PLANNING COMMISSION STAFF REPORT

KINSDALE SUBDIVISION – DESIGN PLAN

Re: Kinsdale Subdivision – Design Plan Review

KINSDALE
 DESIGN PLAN
 THOMAS MILITARY SURVEY No. 1762
 BATAVIA TOWNSHIP
 CLERMONT COUNTY, OHIO
SITE PLAN

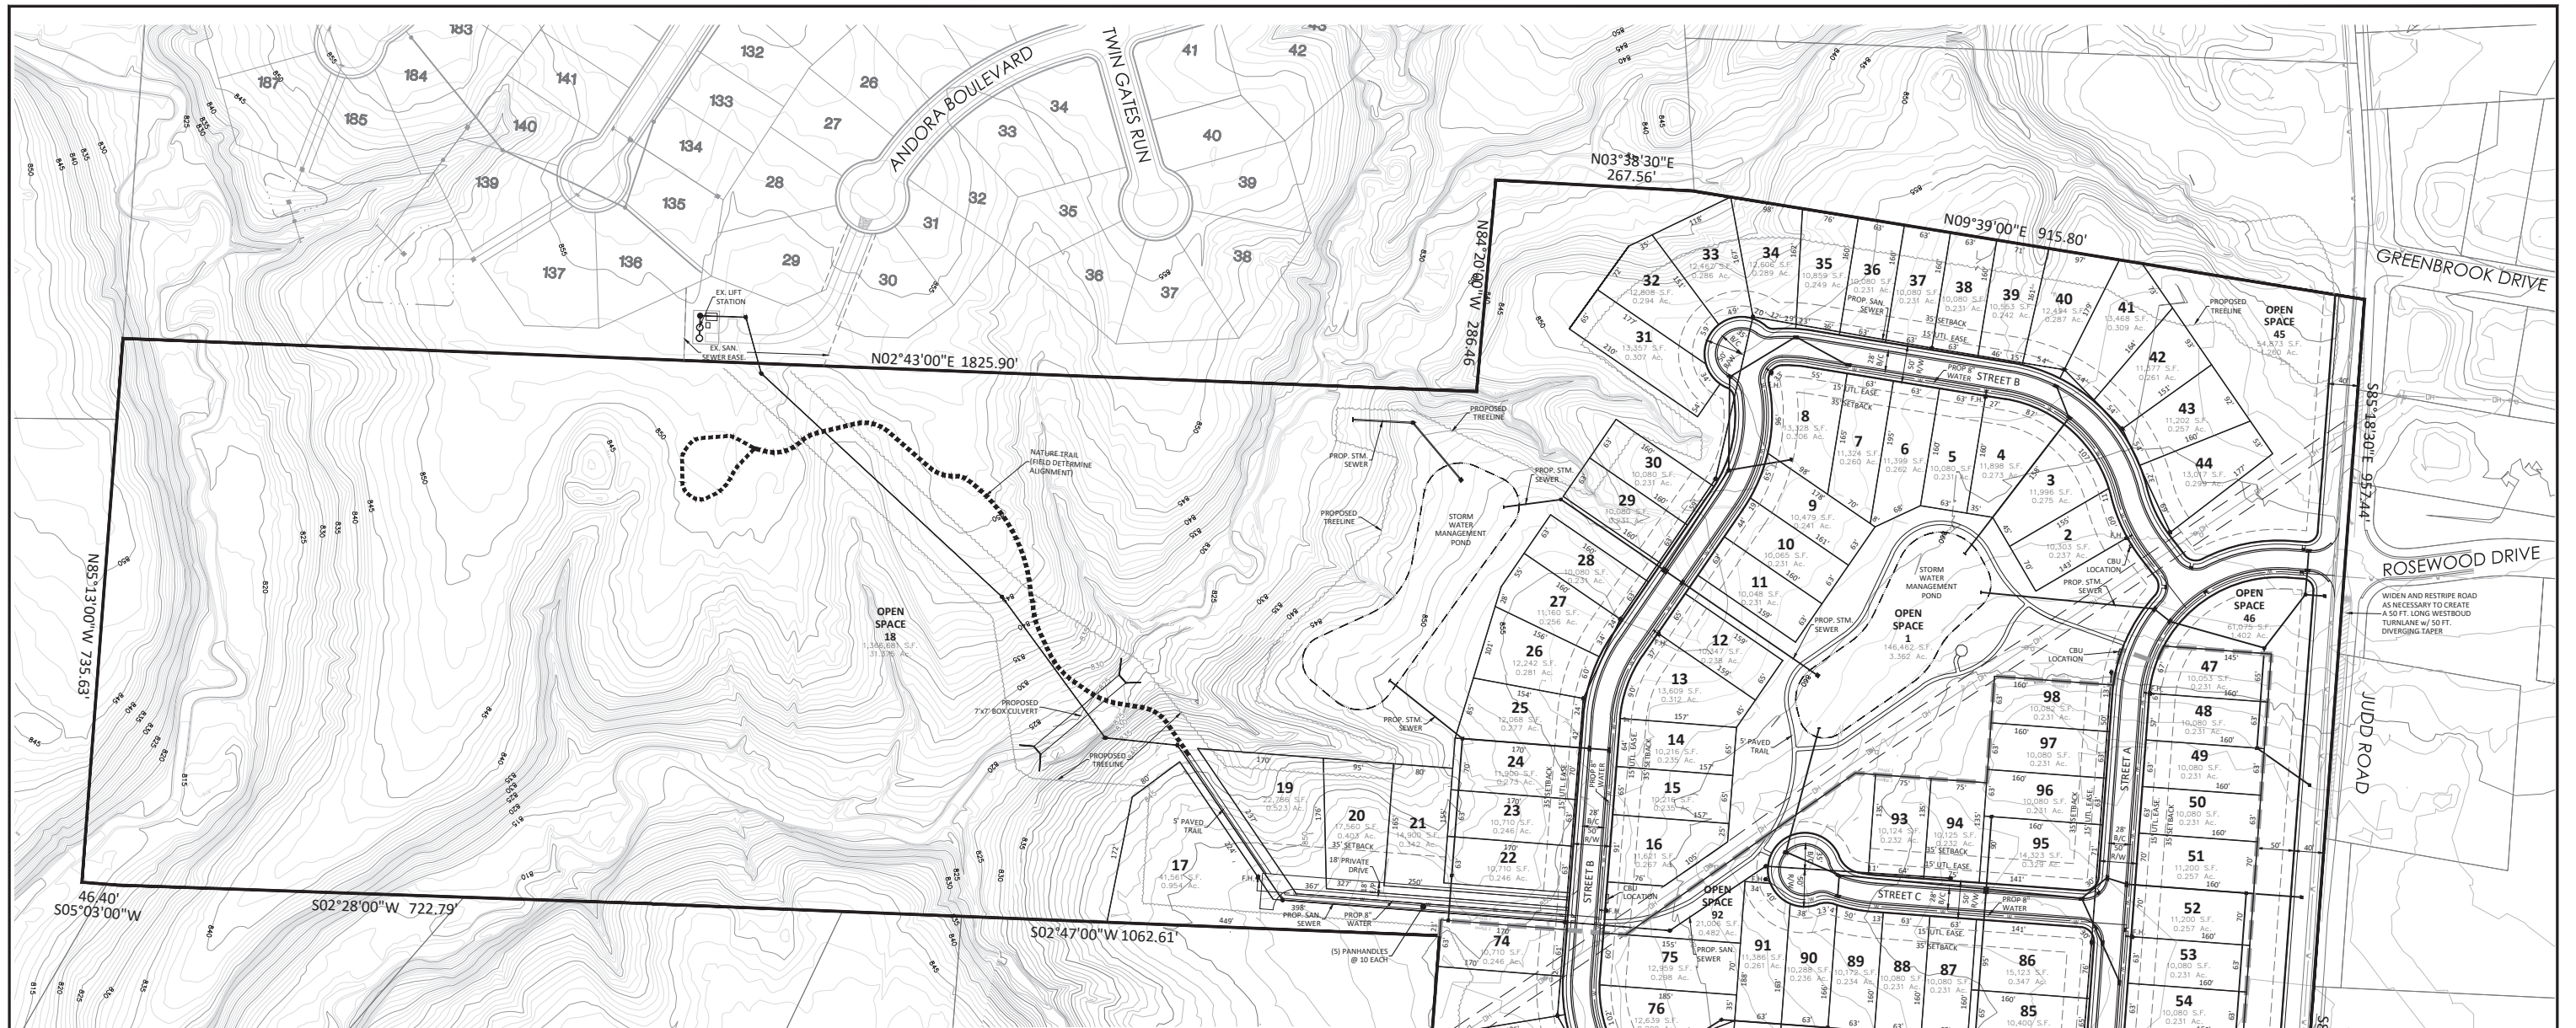
1. Ensure all lots using common driveways provide a driveway easement and maintenance agreement noted on the record plat.
2. Include written scale along with graphic scale.
3. Include names of proposed street(s).
4. Will there be any phases to the project?
5. Application states no units are proposed, 92 is how many there should be.

1. Proper street names need to be provided for the proposed roads upon the plans.
2. Street A must be named Rosewood Drive, as it is a continuation of an existing road.
3. The centerline for proposed Street 'A'/Rosewood Drive needs to align with the existing centerline of Rosewood Drive, at its intersection with Judd Road.
4. The geometry for the proposed Street 'A'/Rosewood Drive Knuckle needs to be adjusted. The proposed centerline radius cannot overlap the proposed Knuckle return radii.
5. The geometry for the proposed Street 'B' Knuckle needs to be adjusted. The proposed centerline radius cannot overlap the proposed Knuckle return radii.
6. A general reminder regarding roadway geometry; the minimum allowable street grade is 0.4%, maximum street grade is 12% (10% preferred), and the minimum centerline curve radius is 200'.

1. The water and sanitary sewers along the assumed private drive for lots 17, 19-21 will need to be located in a 50' ingress/egress & public utility easement, with the water and sanitary mains located outside the pavement limits. The remaining sanitary sewer main from the assumed private drive to the lift station will require 30' exclusive sanitary easement.

2. The proposed sanitary sewer alignment at the lift station is located under the existing generator and chemical tank. It will need to be revised during detailed design

1. Lots 32-34 will likely require geotechnical reports.
2. Easements are needed for all storm sewers outside the public road right-of-way, as well as for the stormwater management basins.

1. The proposed zone change is acceptable based on the recommendations of the 2018 GPP and the current conditions.
2. Modify the Preliminary Development Plan to provide a paper street or future right-of-way for a future street connection to the property to the east in a location between Lots 47 through 54. The Preliminary Development Plan was revised to provide a stub street to the east between lots 64 and 65.

3. Revise the Preliminary Development Plan to indicate the proposed acreage for each open space area.
4. Provide mounding in the open space areas along Judd Road and provide details of the mounding to Batavia Township during Final Development Plan review.

5. Add dimensions to the Preliminary Development Plan to indicate the proposed 50 foot width of the northern open space areas.
6. Provide details of the proposed entry sign for review and approval by Batavia Township during Final Development Plan review.
